Holtec's Position and Proposed Path Forward to Address SFST's Concerns with Respect to The HI-STAR 180 Fuel Basket Material

(USNRC Docket No. 71-9325)
A Presentation to the SFST

by
Dr. K.P. Singh
Executive Engineer
Holtec International
June 27, 2008

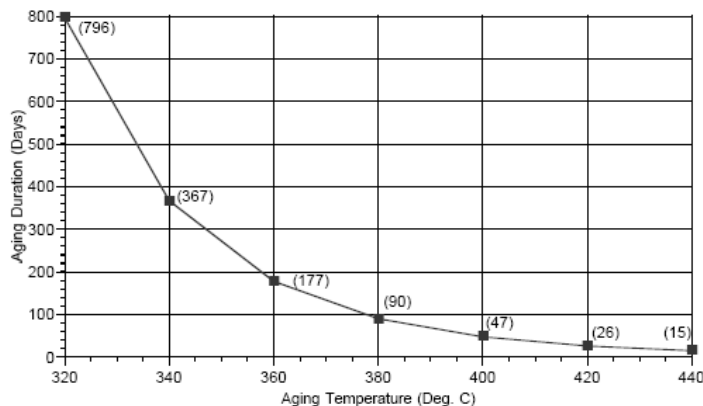
Concern #4: Possible Detrimental Effect of Temperature

4.5 Using the Arrhenius equation, soaking of the coupons for 47 days at 400°C equates to 5 years of soak at 300°C (300°C is the maximum panel temperature under normal condition of transport).

This figure provides the number of days the "HT" panel must be baked at temperature T (320°C < T < 440°C) to emulate 5 years of constant exposure at 300°C.

This figure can be used to conduct an accelerated test to study the effect of sustained heat state on the "HT" material.

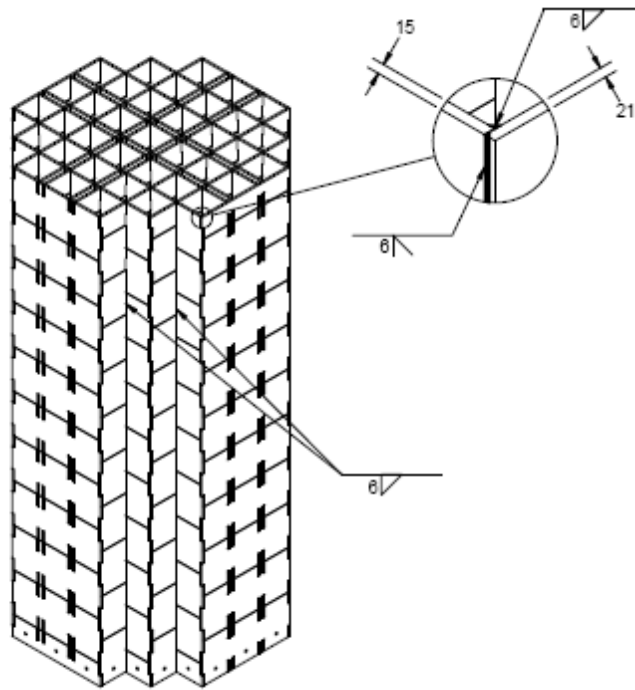
There may be a significant loss of strength in the heat affected zone [2-41] and possible degradation of weld properties under prolonged exposure to the operating temperature [2-42, 2-43].

The F-37 and F-32 basket designs have been slightly modified to re-locate the number of welds (F-37 shown).

The peripheral flat panels have been thickened to 21mm (all other panels remain at 15mm).
